Access Compliance Report

Public Rights-of-Way

(Curb Ramps)

Intersection ID: 1003360	Main Street: HEATHCOTT_CR	Cross Street: N/A	Location: NW
ADA ID: 5A93C4BBF94B	Ramp Type: BlendTrans1	Initial Pass/Fail: Fail	Overall Compliance: No
		Severity Score: 8.75

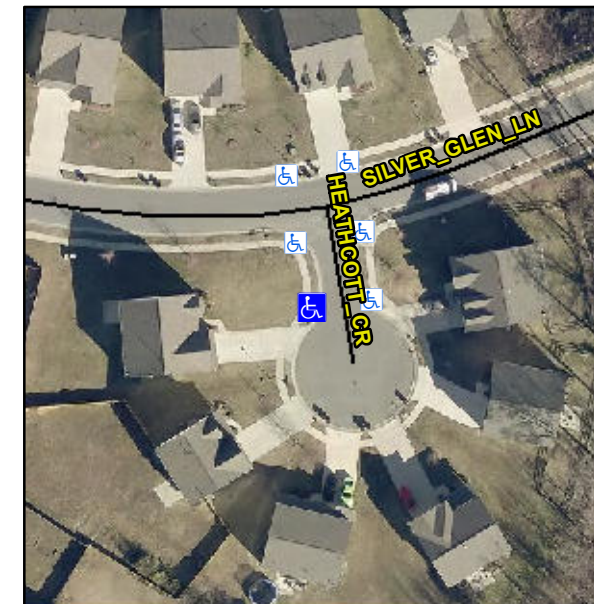
Not Found, R304.5.1

Remove & Replace Curb Ramp With Two New Directional Ramps or Equivalent.
